CERTIFICATE OF AMENDMENT

CORRECTED  
Section V-B - FM BROADCAST ENGINEERING DATA

**BEACON BROADCASTING CORPORATION  
APPLICATION BPED-900905ML FOR A NEW NCE-FM STATION  
ALLENTOWN, PENNSYLVANIA**

**CHANNEL 207A 0.125 KW-V (MAX-DA) 245 M**

EXHIBIT VB-8

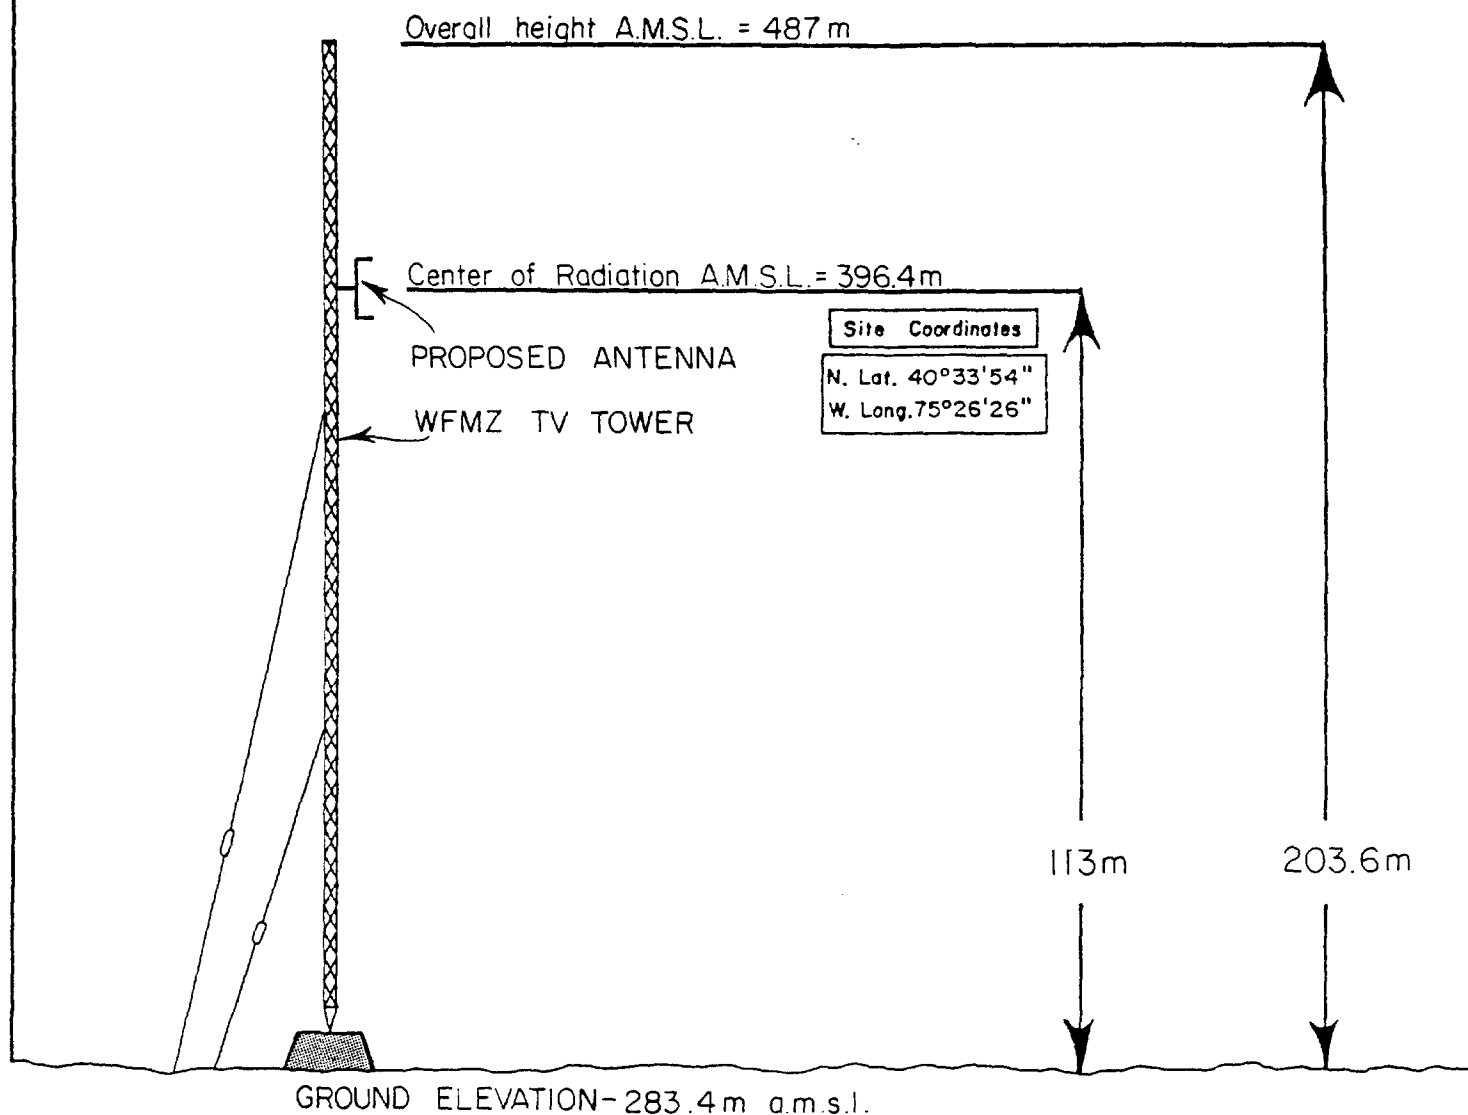
Paragraph 17 of the HDO alleges Beacon failed to address the matter of how they propose to resolve any RF exposure to workers on their respective towers. For clarification, Maranatha Broadcasting Company, Inc., owners and or leasee of the tower, will replace the existing tower with a taller tower. The existing tower will be dismantled after construction of the new tower. Exhibit VB-8 of Beacon's amendment application, addressed the question of RF exposure to workers. As stated in Exhibit VB-8, last paragraph:

The following calculations are performed in order to determine, whether the proposed FM station has a significant environmental effect. The calculations to determine power densities ( $\text{mW}/\text{cm}^2$ ) and power density levels of all TV and FM facilities are computed by using the following equation:

In the above equation, ERP is the total power of horizontal and vertical polarization in kilowatts, distance to a location is in meters and F is the relative field strength towards the location from the vertical plane pattern. For the proposed FM facility, the total ERP is 0.125 kW and the center of radiation is 113 meters above ground. At a depression angle of 90 degrees F is assumed to be 1.0, that is the "worst case" assumption. Therefore, maximum power density for the proposed FM facility at the base of the tower is  $0.000333 \text{ mW}/\text{cm}^2$  or 0.03 percent of the FM permitted maximum. For television station WFMZ-TV "worst case" power density near the tower base, F is 1.0 and aural power is 22 percent of visual. Therefore worst case WVTM-TV power density is  $0.92 \text{ mW}/\text{cm}^2$ . This 34.3 percent of the maximum permitted for operation on channel 69 ( $2.68 \text{ mW}/\text{cm}^2$ ). In the case of station WFMZ(FM) the calculated power density for "worst case",  $F = 1$ , is  $0.065 \text{ mW}/\text{cm}^2$  or 6.5 percent of the FM maximum.

Therefore, the total calculated "worst case" power density at the base of the tower is less than 41 percent of the permitted maximum. Thus, the proposal is in compliance with OST Bulletin No. 65 and the ANSI Standards.

To assure that personnel working on the tower is not excessively exposed, the applicant will reduce power or turn the transmitter off, as necessary, to make sure that such persons will not be exposed to excessive levels of Radiofrequency Radiation.
